IMPORTANT SAFETY RECALL 19V-740

Voyager Industries has decided that a defect which relates to motor vehicle safety exists in certain Yetti Angler; Grand Escape; and Traxx fish houses.

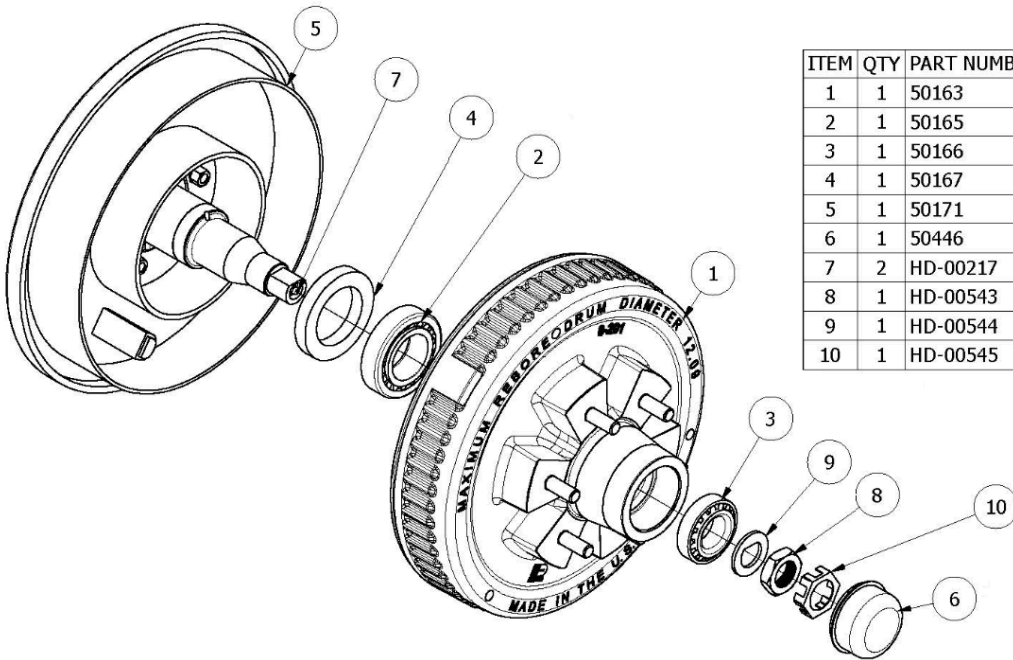
Why is your Vehicle being recalled? These units have a condition in which a safety retainer clip may be missing from the spindle nut. If the clip is missing, over time the spindle nut may loosen and allow the hub and wheel to fall without warning. If the spindle nut loosens or falls off, the wheel may come off the axle assembly, increasing the risk of a crash

Visual inspection for retainer clip *Note: wheel's do not need to be removed*

1. Remove the wheels center cap and then the rubber cap from the dust cover
 - Use a flat tip screwdriver or equivalent tool as shown below
2. Visually verify that the retainer clip is installed
3. Reinstall rubber cap and wheel center cap

What will we do? Voyager Industries will supply at no charge, any missing safety retainer clips. These clips are easily installed with instructions provided with the clips. If you are uncomfortable installing these clips, please contact us and we will arrange for this repair at your location. The repair will take less than 30 minutes.
